Riley Purgatory Bluff Creek Watershed District Permit Application Review

Permit No: 2023-007

Project: Southwest Village Retail - The applicant proposes the construction of a retail building, associated drive-thru lane, landscaping, underground cistern for irrigation reuse, underground stormwater management facility, and a propriety stormwater device to provide water quality and rate control.

Reviewer: Scott Sobiech, PE & Dallen Webster, E.I.T.; Barr Engineering Co.

EROSION CONTROL PLAN

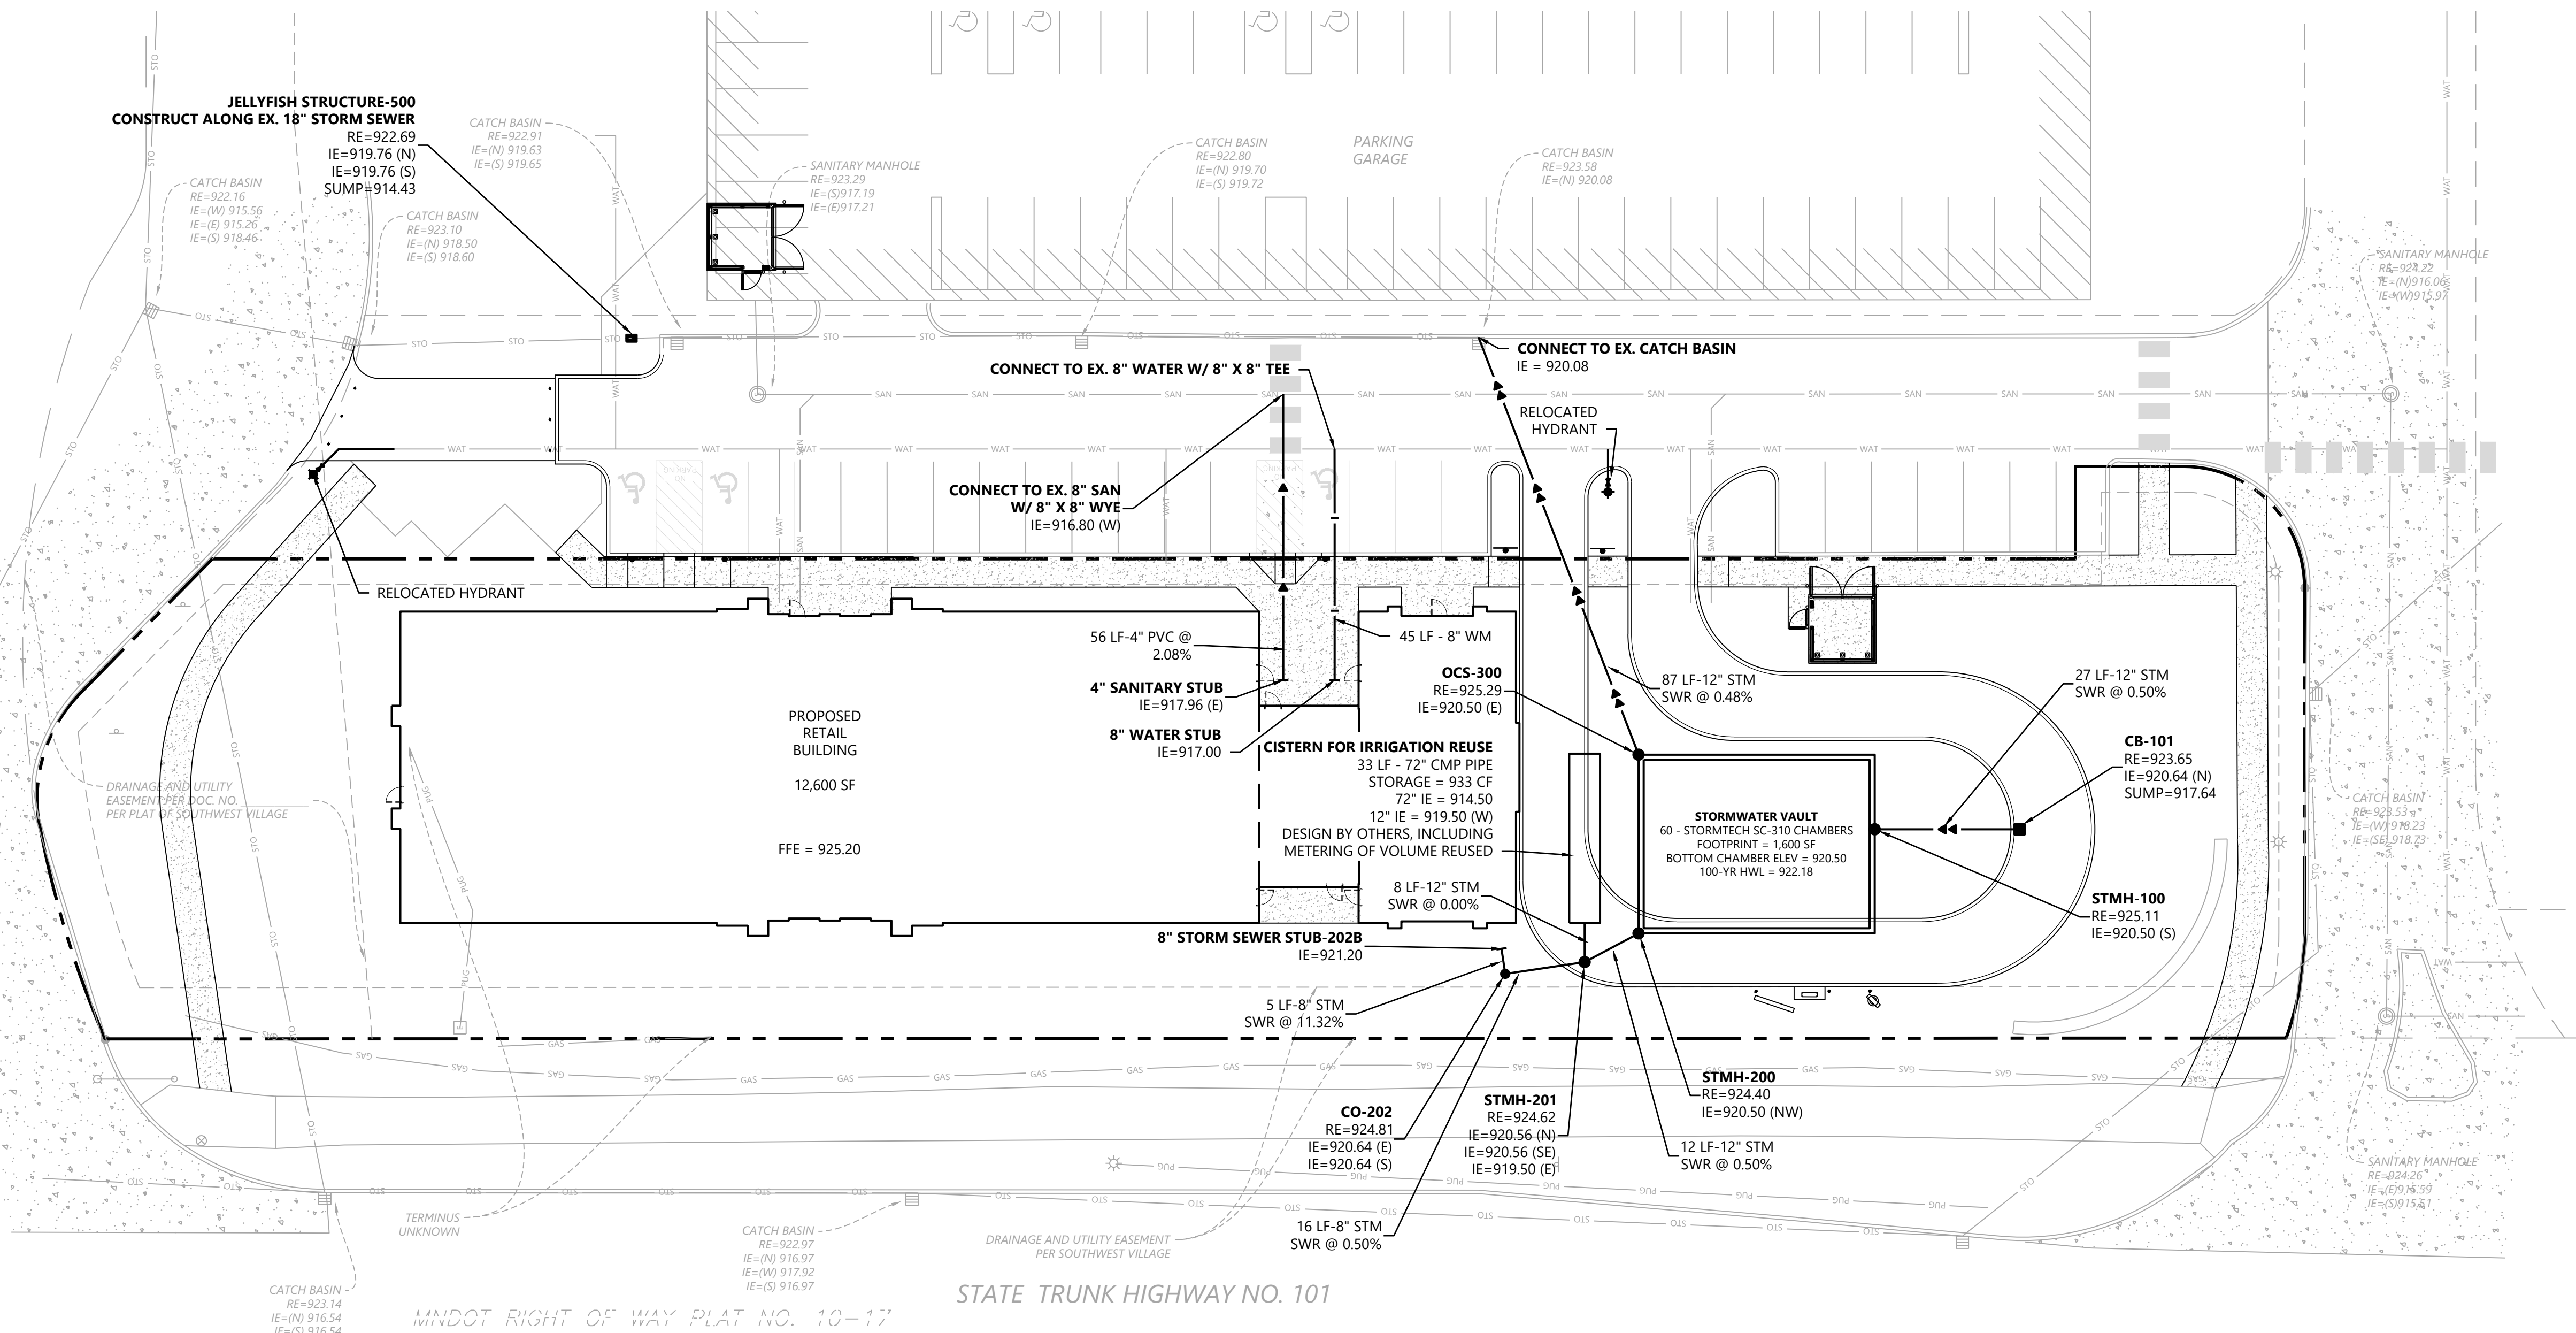
The erosion control plan prepared by Westwood Professional Services includes installation of perimeter control (silt fence), a stabilized construction entrance (Mud Mat), inlet protection, daily inspection, staging areas, placement of a minimum of 6 inches of topsoil (at 5% organic matter), decompaction of areas compacted during construction, and retention of native topsoil onsite to the greatest extent possible. To conform to RPBCWD Rule C requirements, the following revisions are needed:

- C1. The applicant must provide the name, address and phone number of the individual who will remain responsible for performance under this rule and maintenance of erosion and sediment-control measures from the time the permitted activities commence until vegetative cover is established.

1. Permit applicant must provide the name and contact information of the general contractor responsible for the site. RPBCWD must be notified if the responsible party changes during the permit term.
